# UNITED STATES PATENT AND TRADEMARK OFFICE

APPLICATION NO.	FILING DATE	FIRST NAMED INVENTOR	ATTORNEY DOCKET NO.	CONFIRMATION NO.
10/525,705	02/24/2005	Rainer Mathes	Q86114	5900

<b>Office Action Summary</b>	<b>Application No.</b> 10/525,705	<b>Applicant(s)</b> MATHES ET AL.	
	<b>Examiner</b> Ernesto Garcia	<b>Art Unit</b> 3679

Carlson, 2,560,413

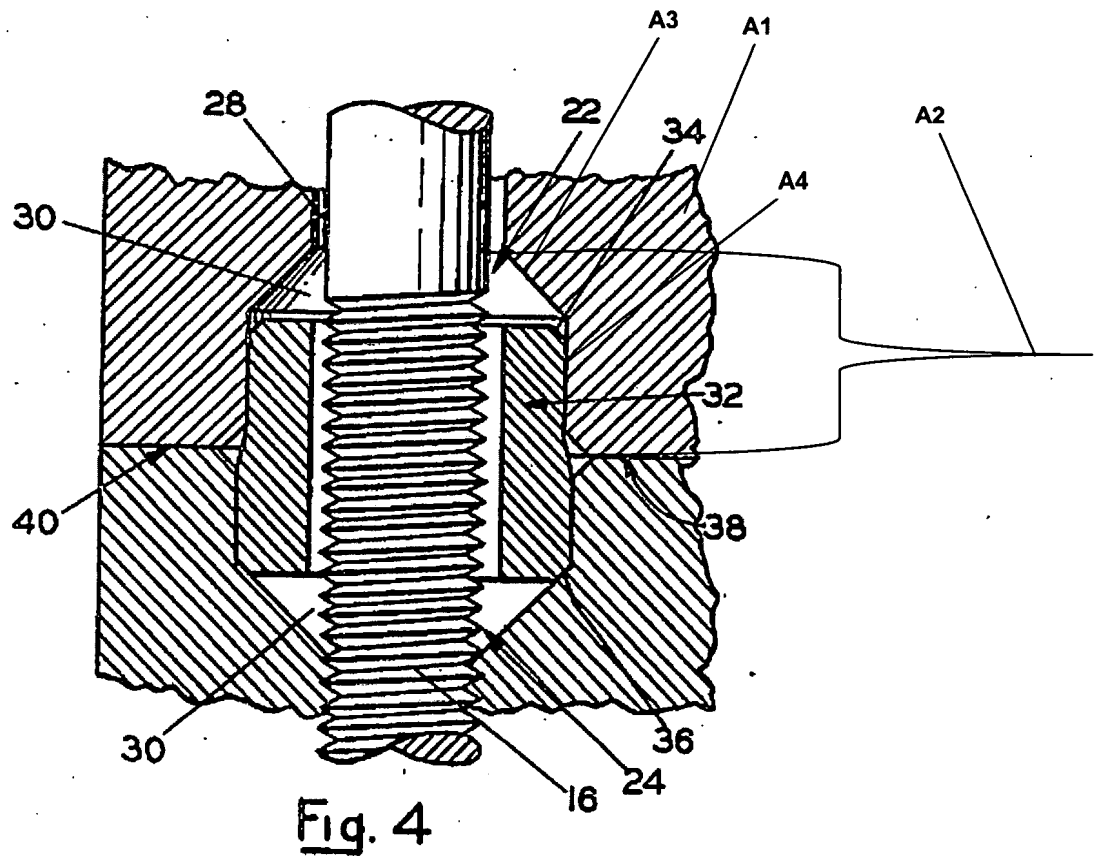
Regarding claim 1, Carlson discloses, in Figures 1 and 4, a faster system comprising a screw **16**, a flange **A1** (see marked-up attachment), and a stationary

structure **14**. The screw comprises a head and a shank. The flange **A1** comprises a through hole **22**. The through hole **22** comprises a distal segment **28**, and a proximal segment **A2**. The stationary structure **14** has tapped holes **26**. However, the flange **A1** in Carlson is not annular any respect but appears square or does the flange include more than one through hole **22**. Weis teaches, in Figure 4, a flange that is annular as part of a design consideration instead of being any other shape than square since rounding the flange to be annular provides for an increase in material toward an outside wall which will handle more stresses than merely being square. Therefore, as taught by Weis, it would have been obvious to one of ordinary skill in the art at the time the invention was made to make the flange annular to provide more material toward the outside wall to handle more stresses during operation of the connection. Further, Applicants are reminded that mere duplication of the essential working parts of a device involves only routine skill in the art. Therefore, it would have been obvious to one having ordinary skill in the art at the time the invention was made to provide more than one through hole in the flange **A1** of Carlson so that the screws provide twice as much clamping force than using one through hole in the flange **A1**. *St. Regis Paper Co. v. Bemis Co.*, 193 USPQ 8.

Regarding claim 3, the proximal segment **A2** includes a cylindrical proximal portion **A4** connected to the distal segment **28** by a circularly frustoconical distal portion **A3**.

Regarding claim 4, the frustoconical portion **A3** has a cone half-angle equal to about 60 degrees.

Regarding claim 11, Carlson discloses, in Figures 1 and 4, a faster system comprising a screw **16**, a flange **A1** (see marked-up attachment), and a stationary structure **14**. The screw comprises a head and a shank. The flange **A1** comprises a through hole **22**. The through hole **22** comprises a distal segment **28**, and a proximal segment **A2**. The stationary structure **14** has a hole **26**. A cross-sectional area of the distal segment **28** taken in a direction perpendicular to a central axis of the through hole **22** is smaller than that of the proximal segment **A2**. The proximal segment **A2** provides a gap. The proximal segment **A2** has an opening sized differently from an outermost

opening of the hole **26** in the stationary structure **14**. However, the flange A1 in Carlson is not annular in any respect but appears square. Weis teaches, in Figure 4, a flange that is annular as part of a design consideration instead of being any other shape than square since rounding the flange to be annular provides for an increase in material toward an outside wall which will handle more stresses than merely being square. Therefore, as taught by Weis, it would have been obvious to one of ordinary skill in the art at the time the invention was made to make the flange annular to provide more material toward the outside wall to handle more stresses during operation of the connection.
